Lime Down

Solar Park

Change Application and Consultation Report (Change Application)

Document Reference: EXAM/9.40

Title:
Works Plans Comparison
- Change 1

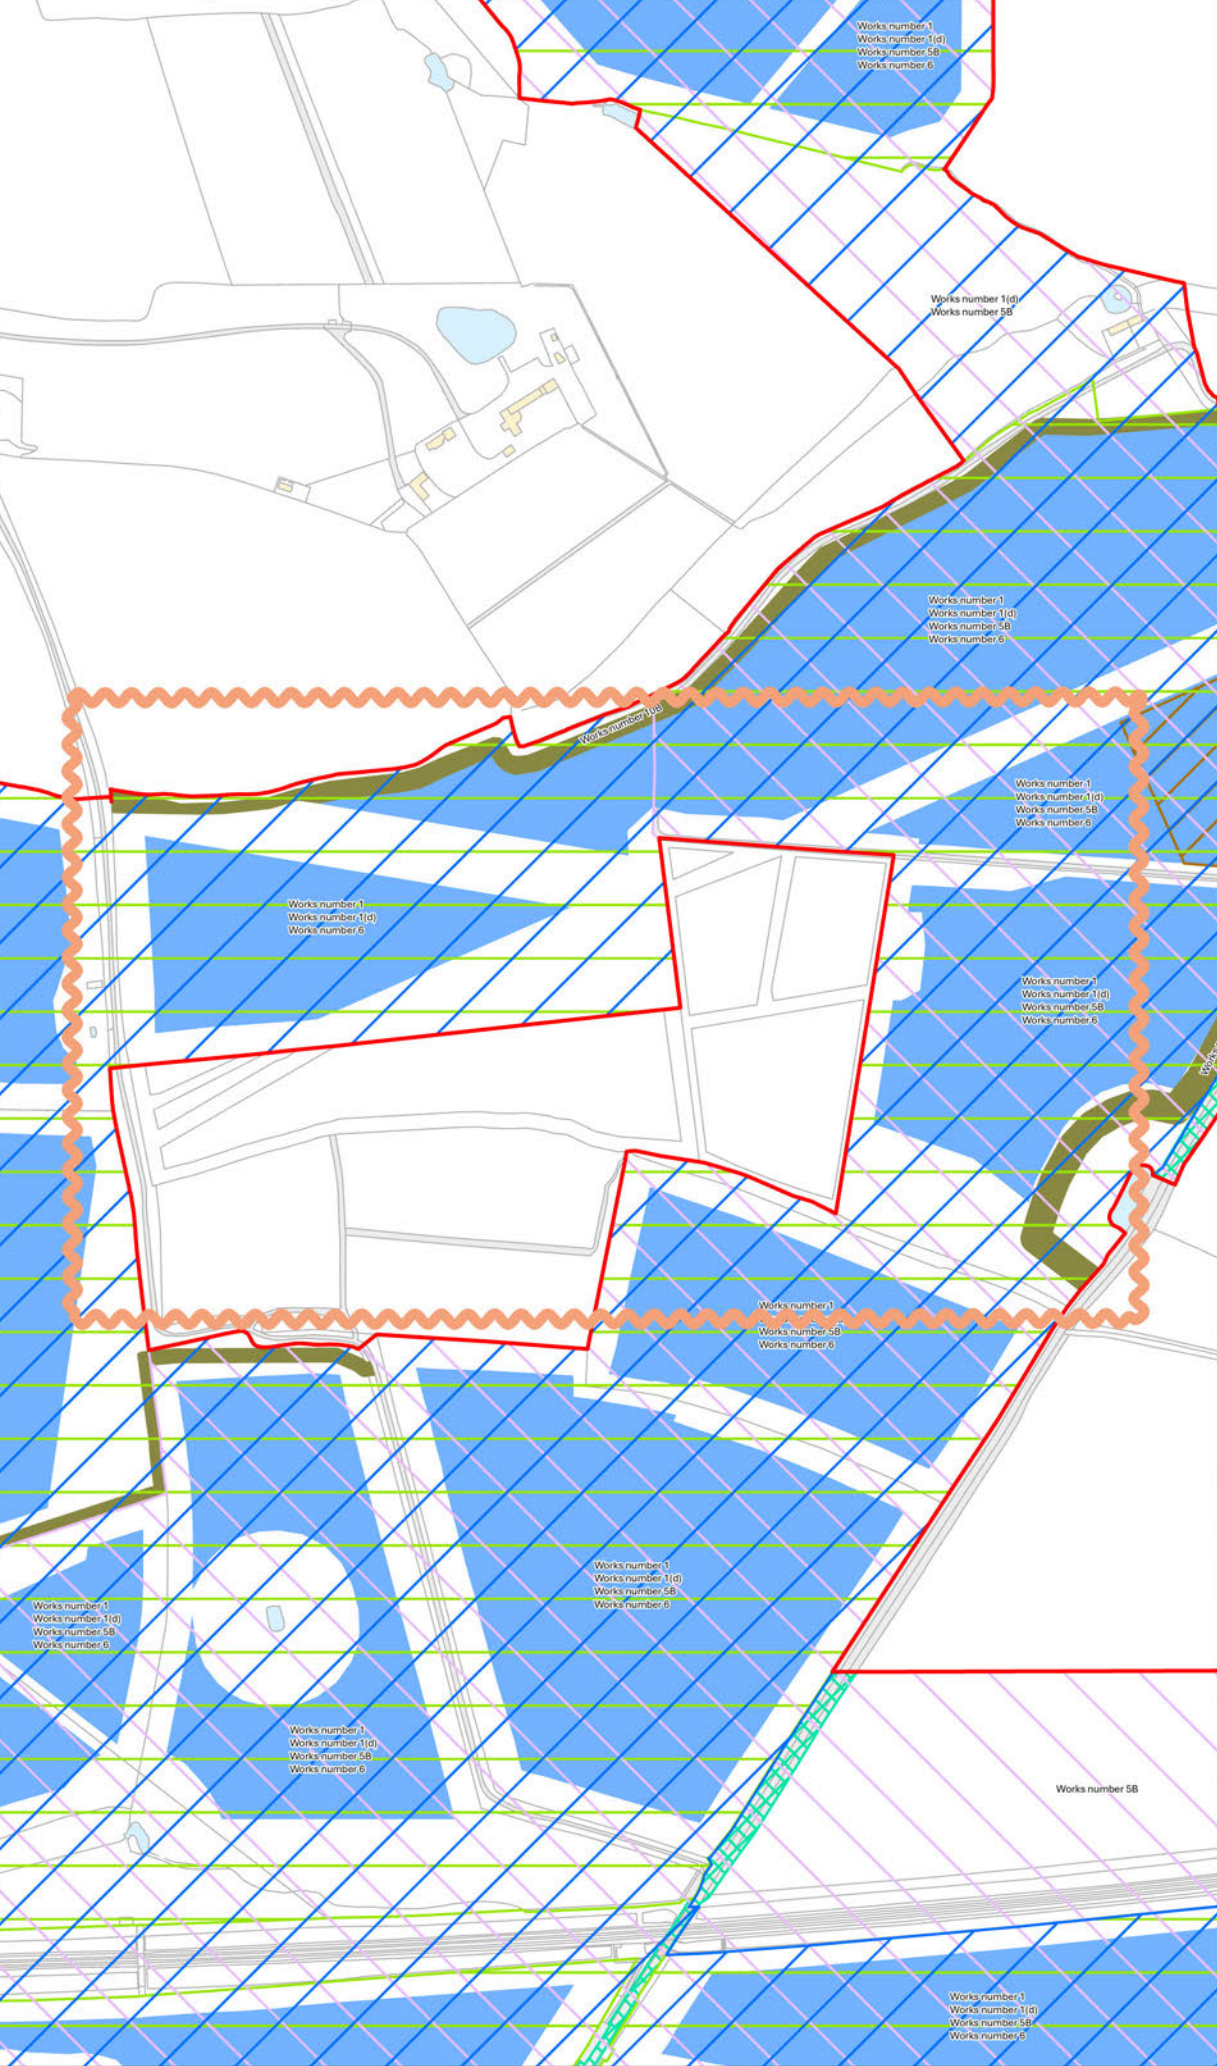
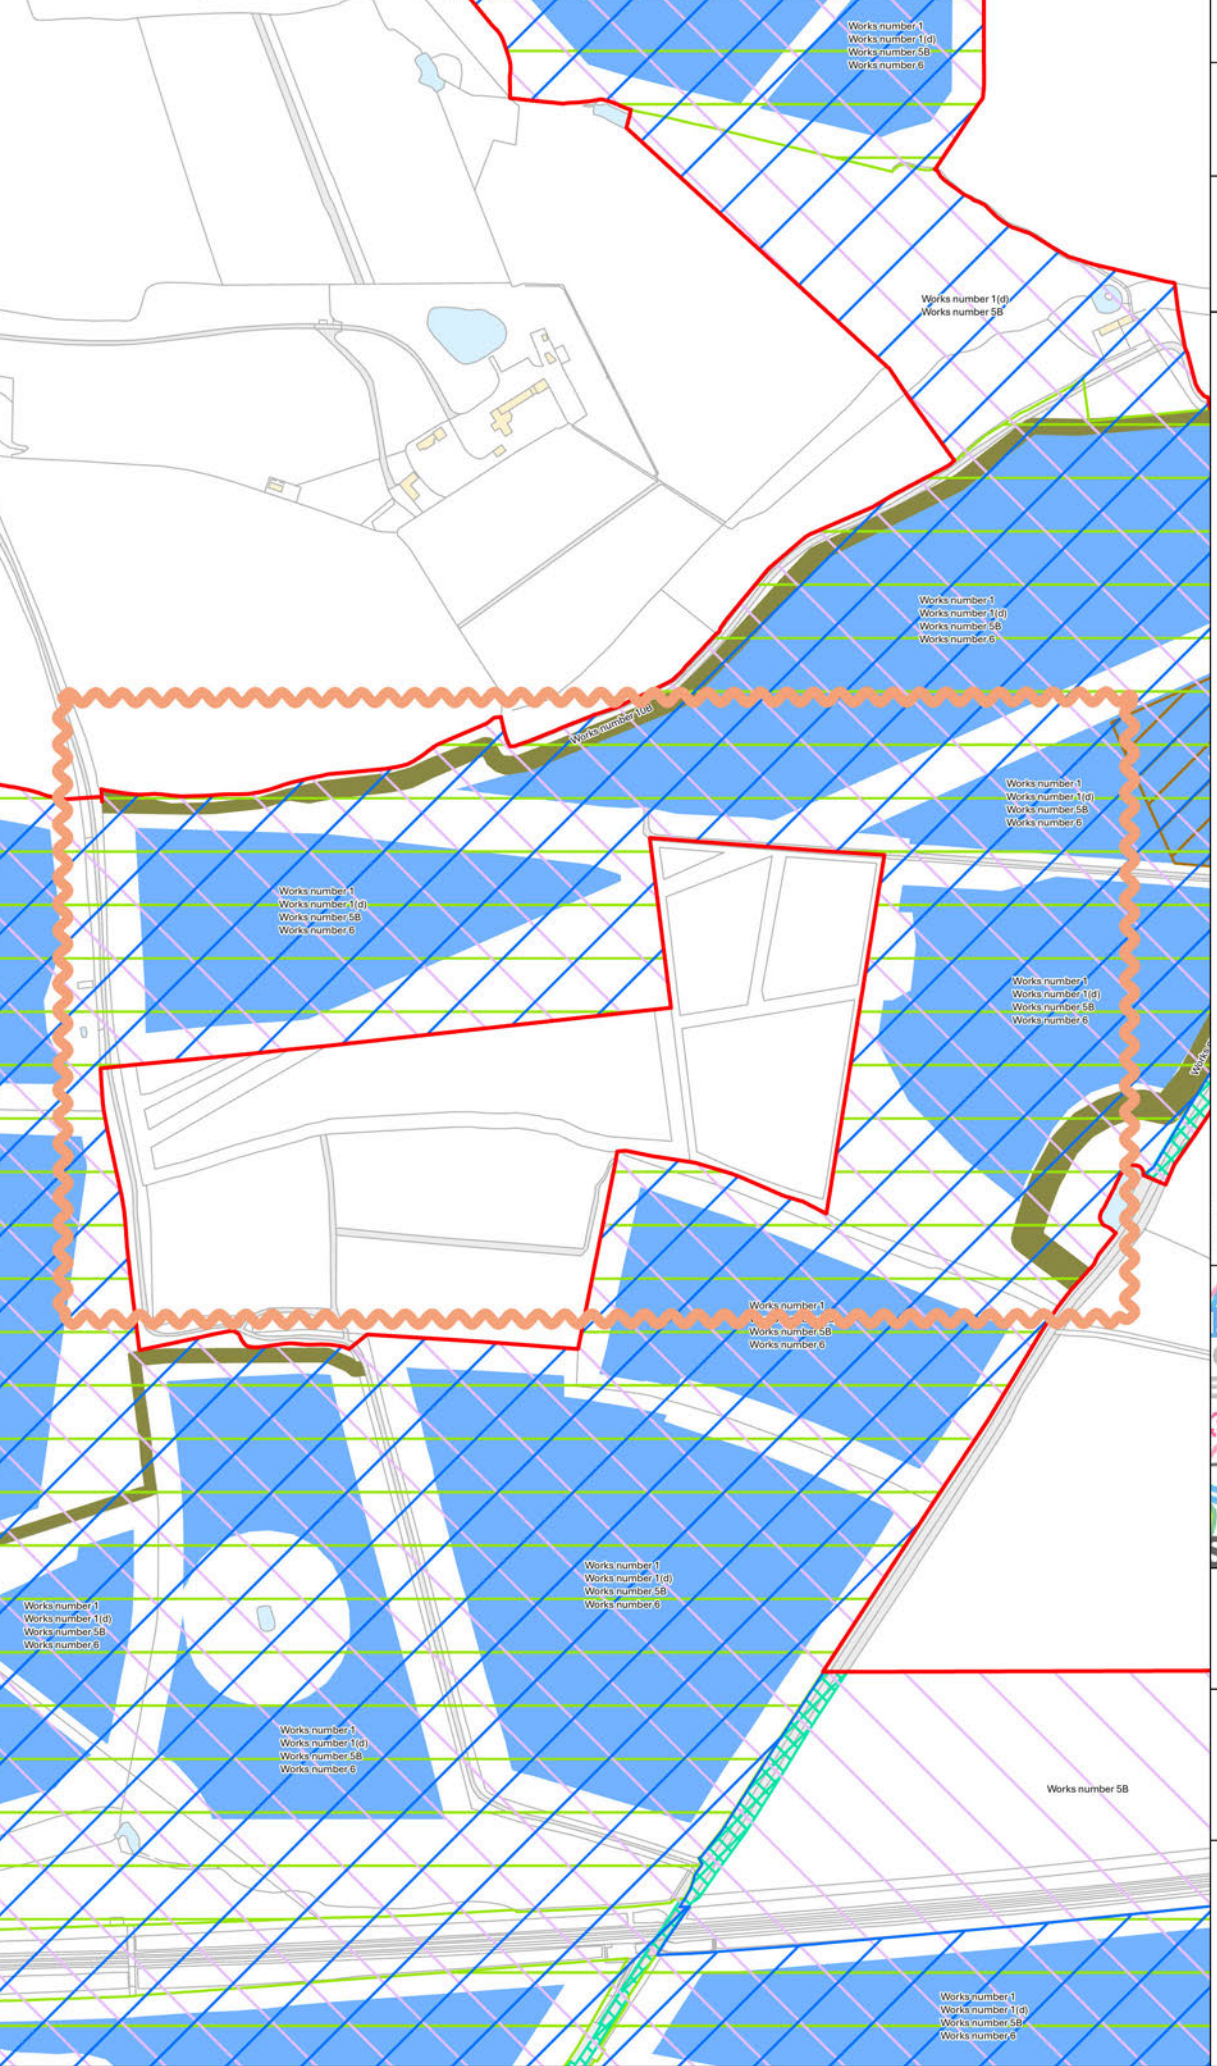
Change 1: An extension of the Order Limits at Lime Down D to allow the emergency access to connect with the public highway

3.1.3 Change 1 comprises an extension to the Order Limits from the south western extent of the BESS emergency access (Access 21, as set out in Table 2 of the **Outline Construction Traffic Management Plan (CTMP) [REP3-108]**) at Lime Down D to the public highway named Hills Hayes Lane. A post-submission review by the Applicant of the Scheme accesses indicated that Access 21 did not adjoin the boundary of the public highway. This change will allow emergency Access 21 to tie into the public highway. The additional land will contain the bellmouth of emergency Access 21 which will comprise hardcore or gravel over a levelling layer of substrate. The additional land will be subject to Work Number 8b.

3.1.4 The area of the land to be added to the Order Limits is approximately 0.044ha. Given the small area of land proposed to be included within the Order Limits, the Applicant considers that the same reasons already provided for within the **Statement of Reasons [EN010168/APP/4.1] [Change Application]** apply to the land added to the Order Limited. Accordingly, there are no changes to the Statement of Reasons proposed as a result of the Change Application, and the reasons already set out in the Statement of Reasons are relied on to justify the modest increase to the Order Limits.

3.1.5 This land will be subject to compulsory acquisition of the rights, and is shown in blue on Sheet 4 of the **Land Plan [EN010168/APP/2.2] [Change Application]** forming Plot 04-036 which has increased in size from 83 to 525 square meters. This comprises land that forms part of the public highway where temporary possession powers are required. This ensures that any works to create the bellmouth junction can be carried out. The **Works Plan [EN010168/APP/2.3] [Change Application]** have also been updated to reflect Change 1.

Title:
Works Plans Comparison
- Change 2

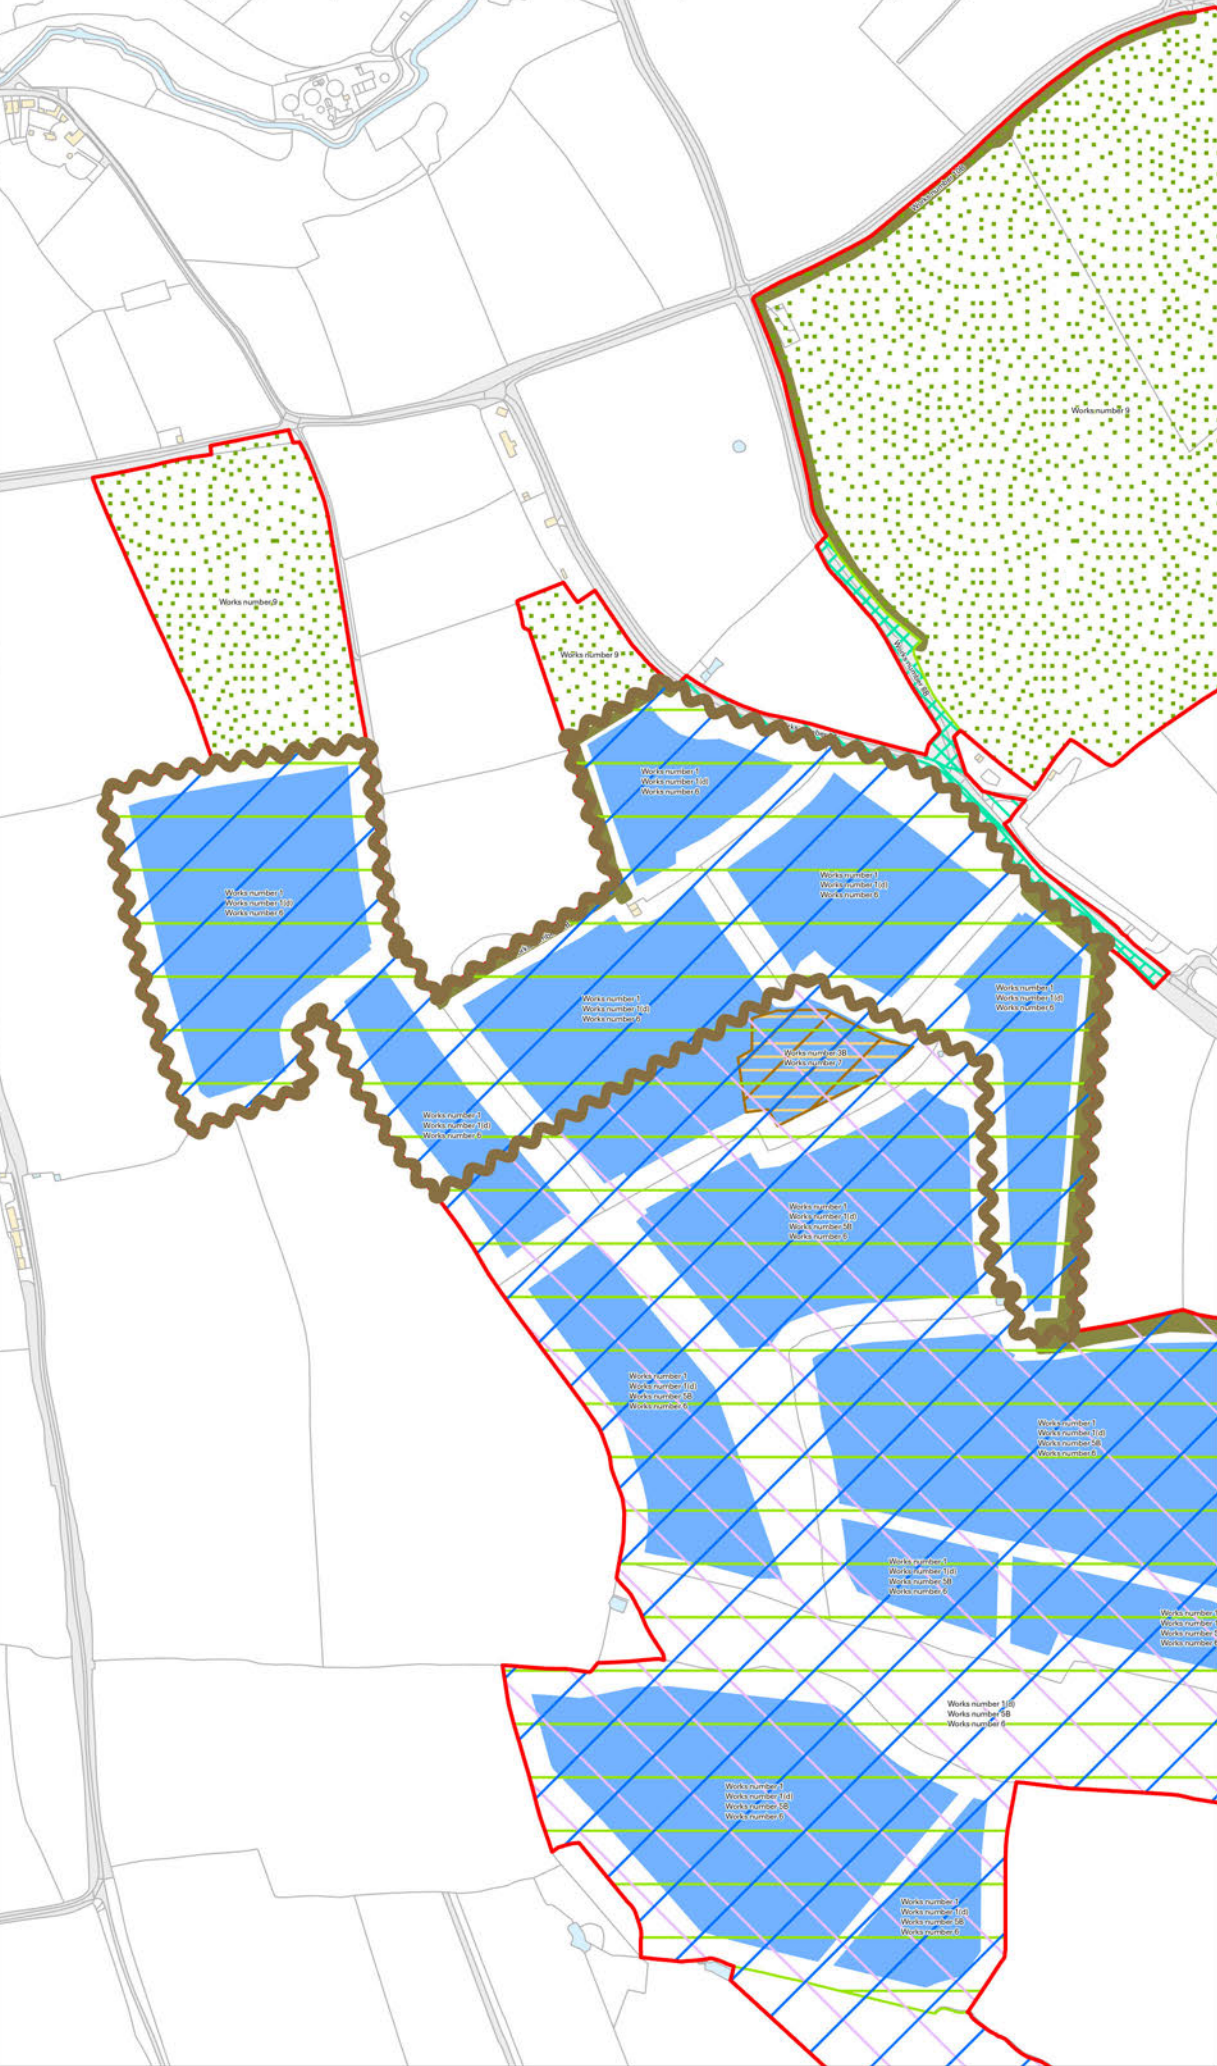
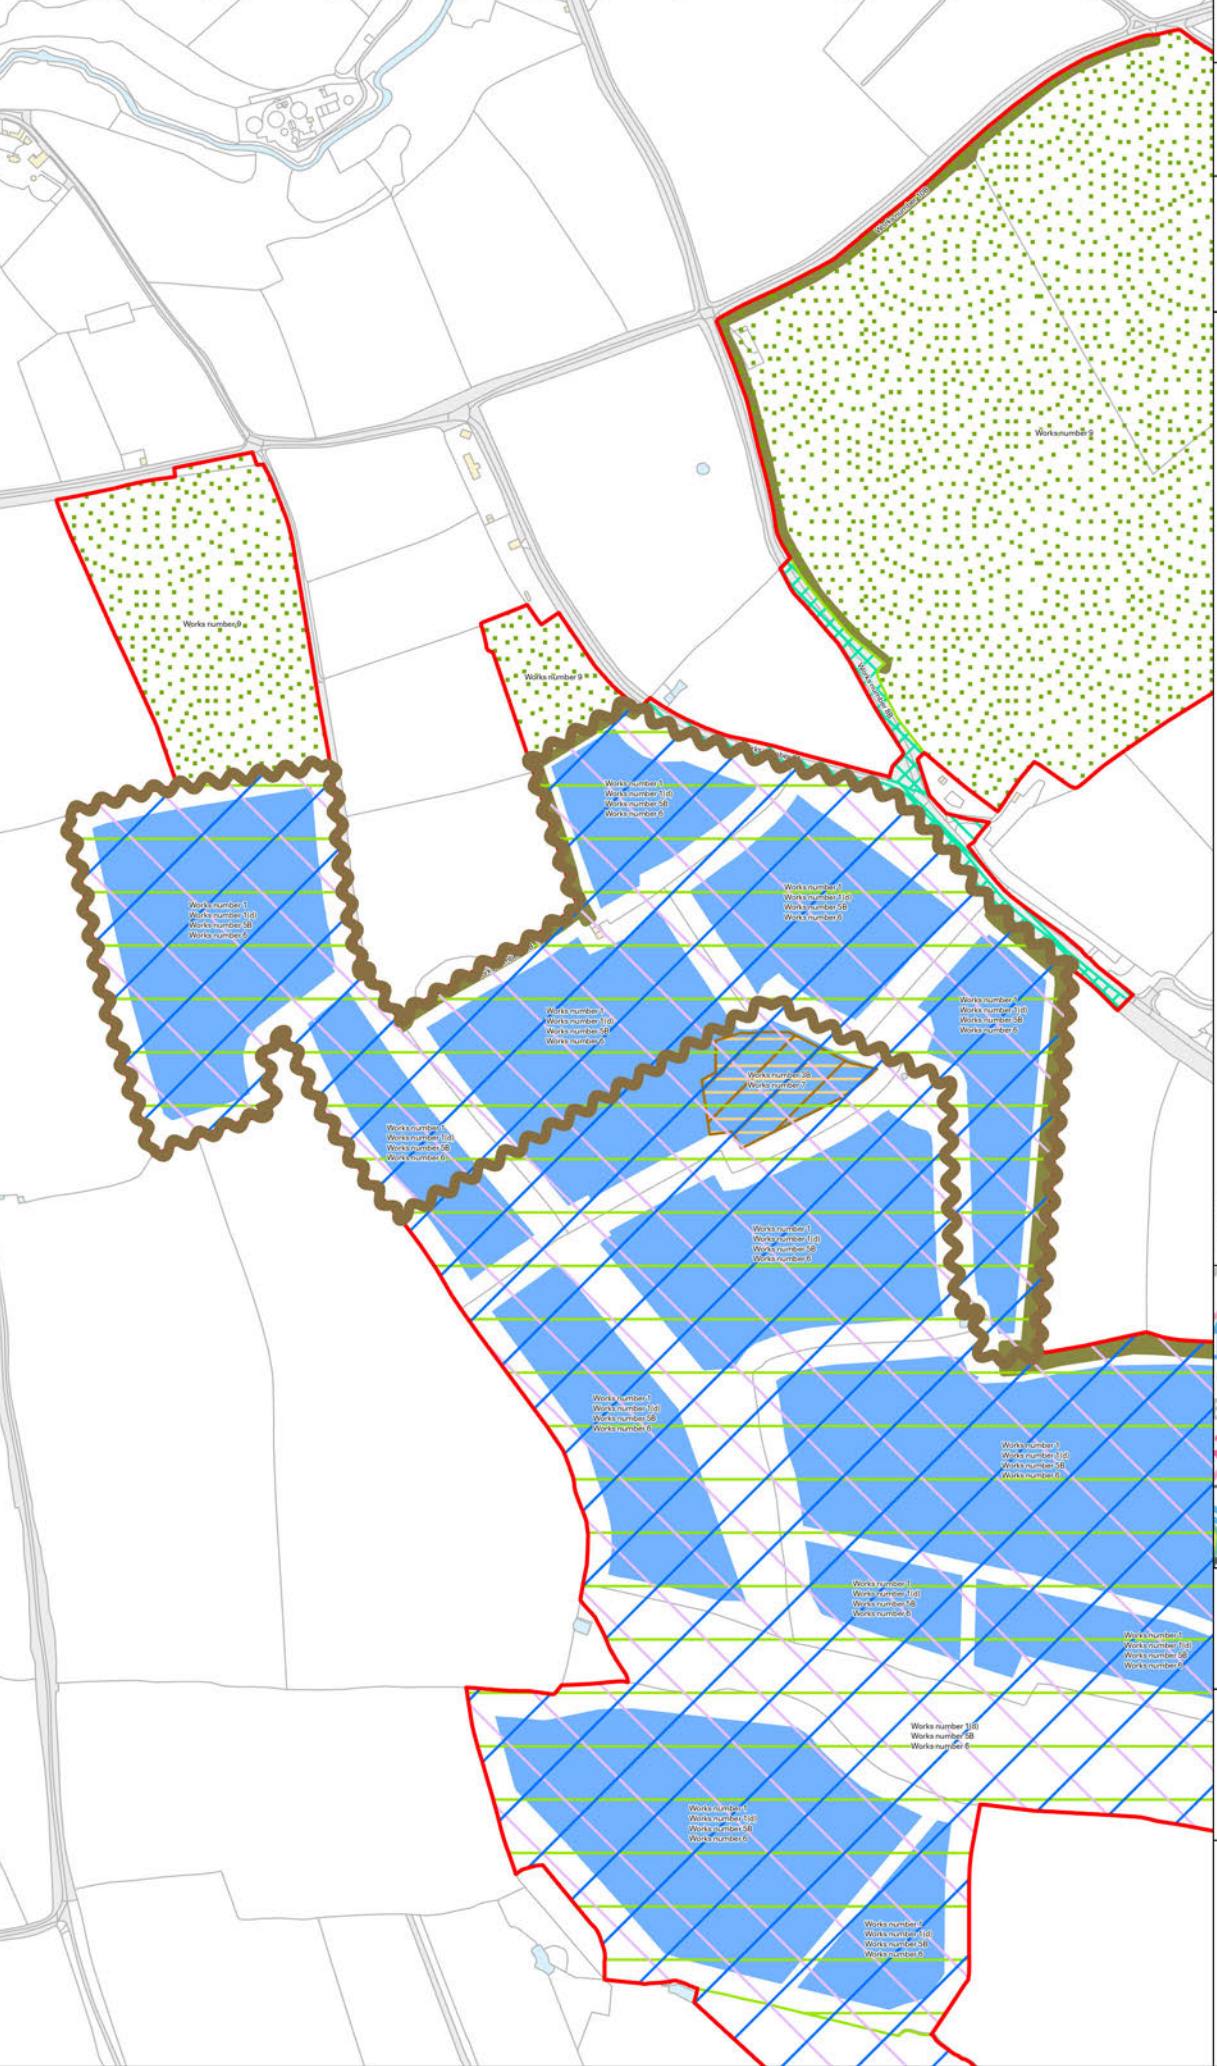
Change 2: Realignment of Solar PV Infrastructure from parts of Lime Down C to allow PRow WT/SHER/18 to be realigned

- 3.1.7 Change 2 comprises an update to the Works Plan to reflect the realignment of Solar PV Infrastructure within parts of Fields C21 and C23. This change reflects updated GIS data provided by Wiltshire Council that confirms the alignment of PRow WT/SHER/18 as per the definitive map dated 5 March 2026, which has changed since the DCO Application was submitted.
- 3.1.8 There will be no change to the extent of Work Number 1, and the realigned Solar PV Infrastructure will retain a 15m offset from the PRow.
- 3.1.9 The **Works Plan [EN010168/APP/2.3] [Change Application]** and **ES Volume 2, Figure 3-4 Landscape and Ecology Mitigation Plan [EN010168/APP/6.2] [Change Application]** have been updated to reflect Change 2.
